Issues with LLDP over LAGs

IEEE 802.1 Contribution

Maintenance Item – 0009

Disambiguating LLDP over Link Aggregations

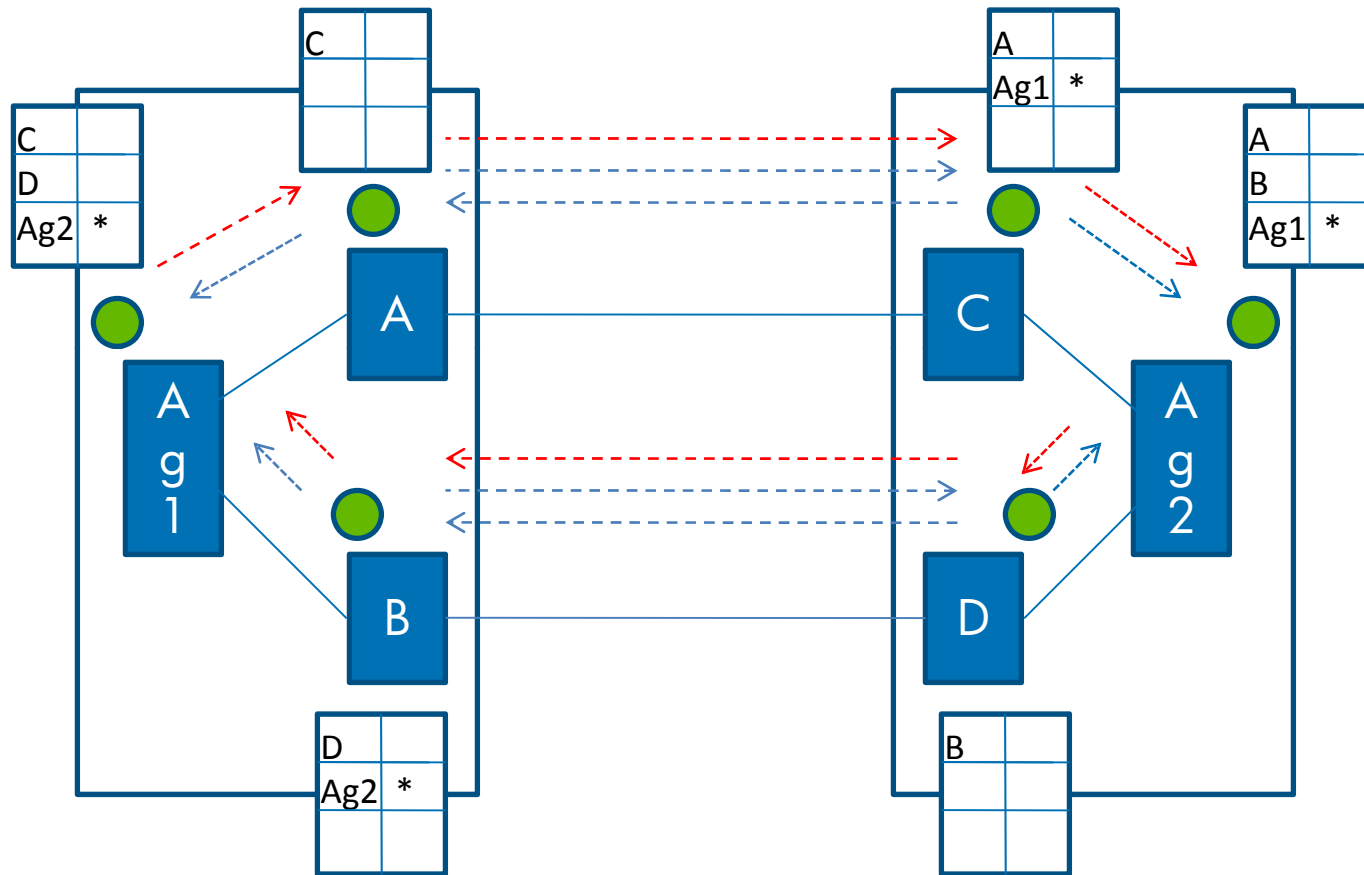
- Submission: Jeffrey Lynch – September 2011
- Issues:
 - It is unclear how LLDP should operate over an aggregation
 - It is currently not possible to determine at the receiver if the LLDP frames were sent from a peer at the physical link or at the aggregate

- Proposed Resolution:
 - Document in IEEE 802.1Q or IEEE 802.1AX the requirements and operational behavior for LLDP in the presence of Link Aggregation

- Either redefine the use of some of the reserve bits or add new fields to the existing LAG TLV (to disambiguate the source & target of LLDP frames)
 - Identify which TLVs should be sent on each individual link or on the aggregate

- Resolve the architectural addressing issues introduced by running LLDP over a LAG.
- Discussion
 - There is some question as to whether you can actually send/receive LLDP frames at the physical layer because of the way it has been specified originally in 802.3. If that is true, then we have a new feature requirement for 802.1AX and it is needed to send/receive at the physical layer. This aspect could be put into AXbq.

Figure E.7—Link Aggregation TLV format

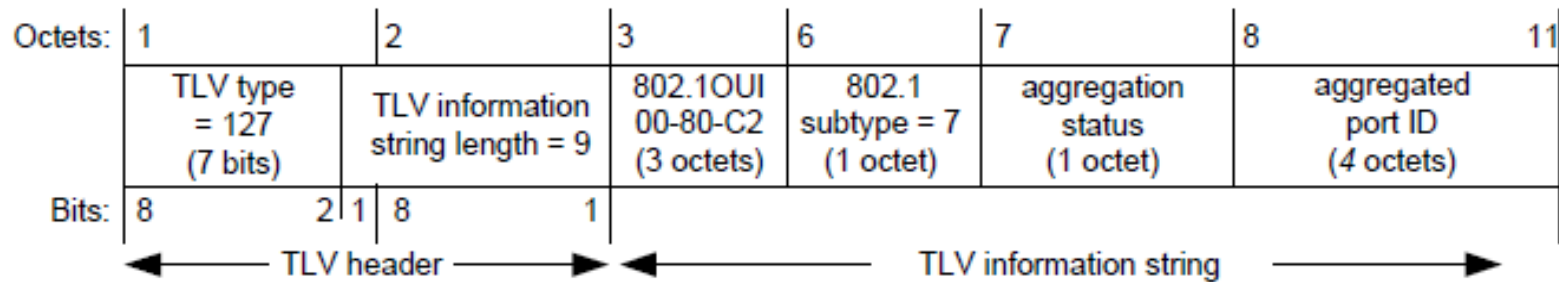
Require LinkAgg TLV

(Define the use of some of the reserve bits to the existing LAG TLV)

- Aggregation portID can not be the same as any physical portID for this to work.
 - Chassis-ID+Port-ID must be unique for each agent to be identified. If the aggregate uses the same Chassis-ID+Port-ID the receiver will wipe-out previously received data.
- This proposal makes it impossible to aggregate an aggregation.

- Agents on physical links
 - Aggregation capability = 1
 - Aggregation status = 1
 - Aggregation component = 0
 - Aggregated PortID = PortID of aggregated link
 - PortID TLV = physical link PortID
- Agents on aggregates
 - Aggregation capability = 1
 - Aggregation status = 1
 - Aggregation component = 1
 - Aggregated PortID = PortID of aggregated link
 - PortID TLV = aggregated link PortID
